# JOHNSTON COUNTY ENVIRONMENTAL HEALTH DEPARTMENT

205 South Second Street  
Smithfield, North Carolina 27577  
Telephone (919) 989-5180  
IMPROVEMENT PERMIT

Application No.: 58697  
Tax Map No.: \_\_\_\_\_  
Date: 4-26-02

Location: Echo Forest - Buffalo Rd to Wendell Rd 7-5 miles on

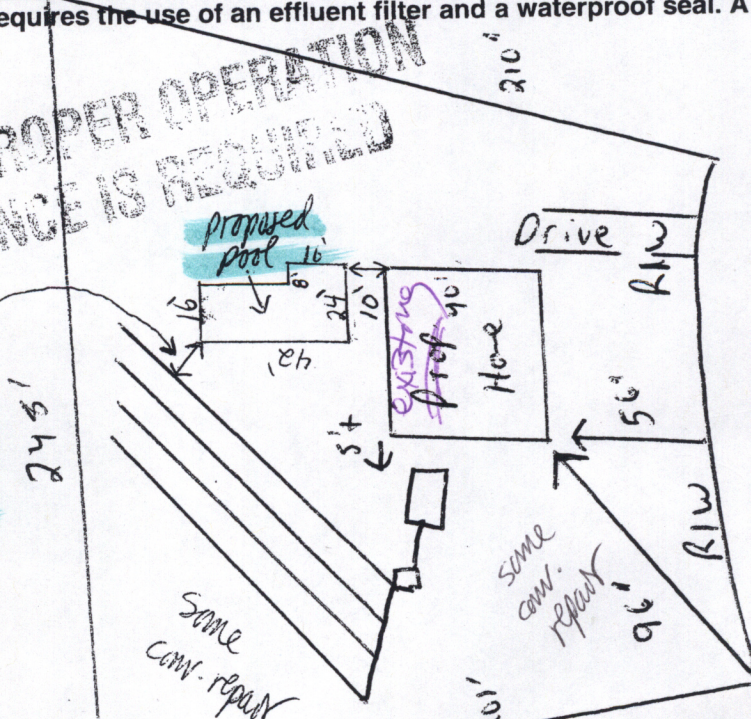
maintain 15' from surface of water to top drain line (marked by white flags)

NOT TO SCALE  
permit revised 4/19/05  
to show location of  
proposed pool (reinspection  
permit # 69692). DEP

Keep right edge of  
pool even with right  
edge of house, or no  
more than 1' (one foot)  
to the left of right  
edge of house.
